European Union Agency for the Cooperation
of Energy Regulators

Analysis of the Consultation Document on the Gas Transmission Tariff Structure for Slovenia

NRA: Agencija za Energijo
TSO: Plinovodi

17 November 2021

Figure 1: Scheme of the Slovene transmission system.

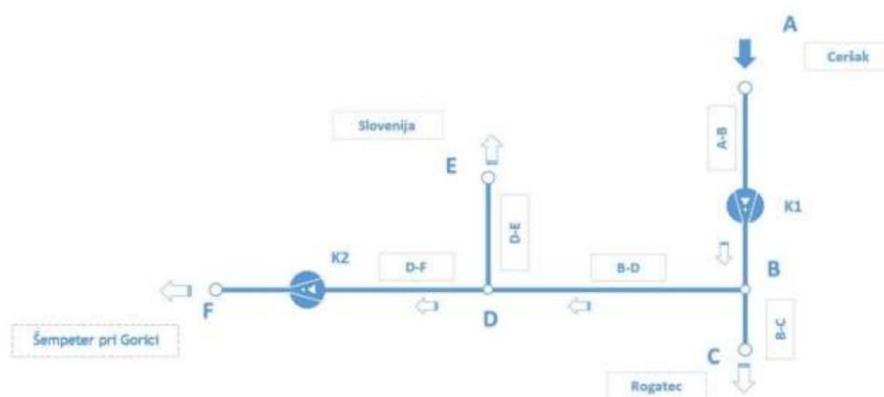
- (30) The Agency recommends that the NRA provide additional transparency on the parameters and the unit costs that are an input to the RPM, including the details of the underlying parameters and assumptions used. This information should provide sufficient transparency to allow understanding how each of the input parameters to the RPM are calculated and how they impact tariffs. The transparency provided should allow sufficient visibility to rule out any incompliant allocation of revenue in each of the steps in the calculation of tariffs.

- (32) Plinovodi explains in the consultation document that the Slovene network was originally designed for supplying large industrial customers. The Agency points that there are a number of pipeline segments that seem to be exclusively dedicated to the supply of domestic users. This point has been confirmed by the TSO. In the 2020 Report *The internal gas market in Europe: The role of transmission tariffs*¹², the Agency referred to such infrastructure as 'regional networks' and notes that the cost allocation of these regional networks, together with the rest of costs associated to the access to networks, could be an important factor leading to cross-subsidisation between cross-system and intra-system users. Such concern can be raised on the RPM consulted by Plinovodi.

- (33) The division of the network into sections allows Plinovodi to cluster all exits to domestic points in a single section. Clustering these points allows allocating these costs to domestic points, thus avoiding that they are allocated to other points of the network, such as cross-border IPs. The Agency considers this approach appropriate for the allocation of the revenue associated with domestic points that can potentially be part of regional networks. At the same time, the Agency refers to the need of improving transparency as detailed in paragraph (30) above.
